***Top Workmanship Quality Issues:***

**Timeframe:** [May 2006](#)

**Snap Shots of the Month**

**Routing Cables**

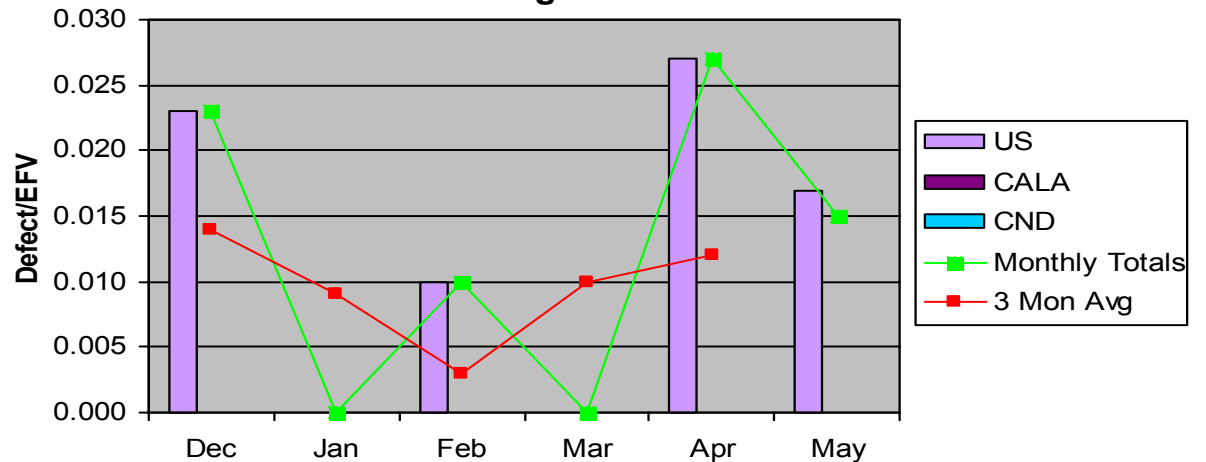
**Routing Cables:** Fiber Management issue Fiber Cable is not to run outside of its dedicated management system.

Incorrect cable routing places risk of damaging the cables which would lead to a service interruption.

Failure to follow proper procedure. During the fiber routing process technician did not notice the fiber was out side of the fiber duct. Over look during final site inspection.

**Correct Method :** Fibers cables to the right are correctly routed.

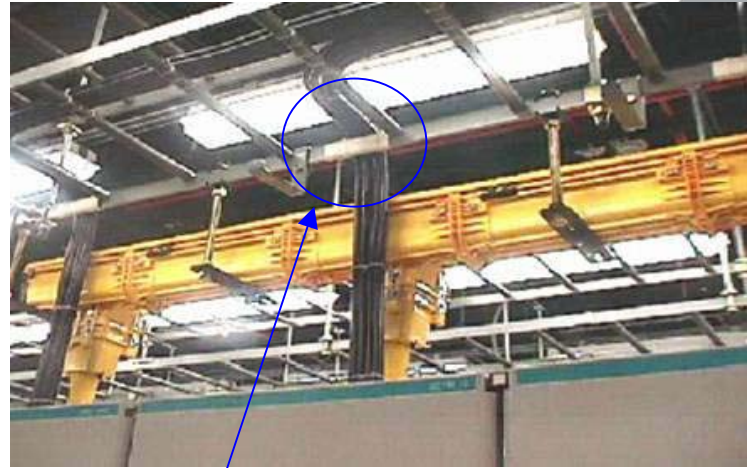
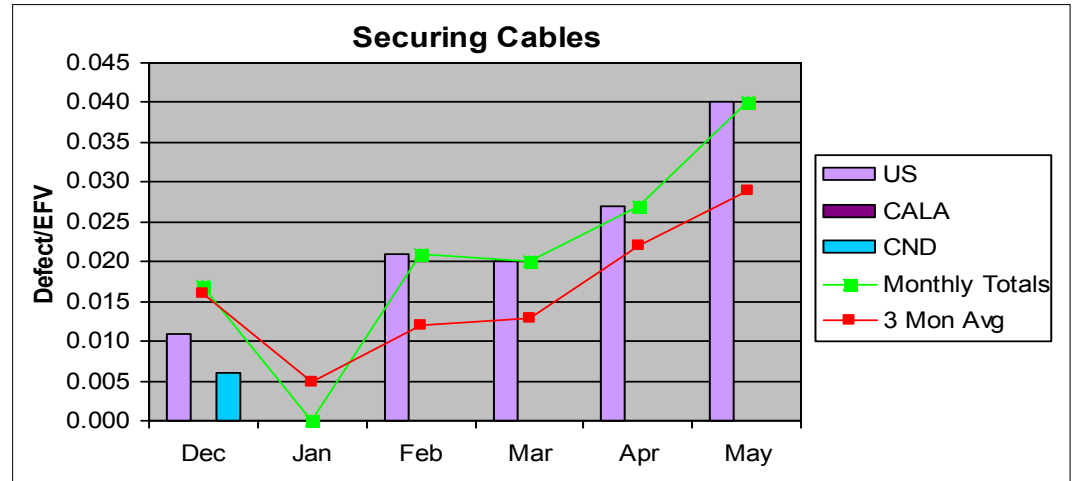
**Securing Cables:** Cables are not secured and no cable protection added.

Improper, not securing cables and not cable protection can create a risk of damaging the cables. Which can lead to a service interruption.

Technician followed existing pattern, existing cables were not secured to the rack at break, our cables added to the bundle.

**Correct Method :** Cables are properly secured to the cable rack.

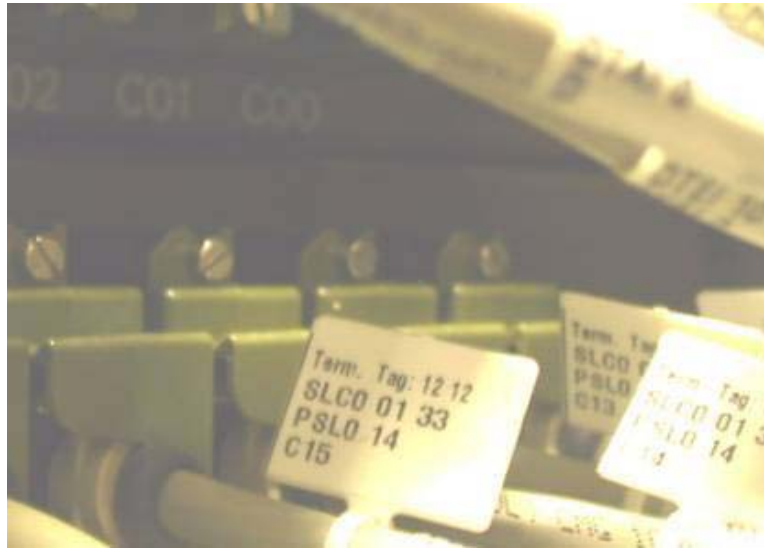
**Cabling (Non-Fiber) designations :** Incorrect cable designations for the terminating end on the on the SLC Bays. It should be terminating to PNL 36 instead of PNL 33 and connection points at C12-C14 instead of C00-C03.
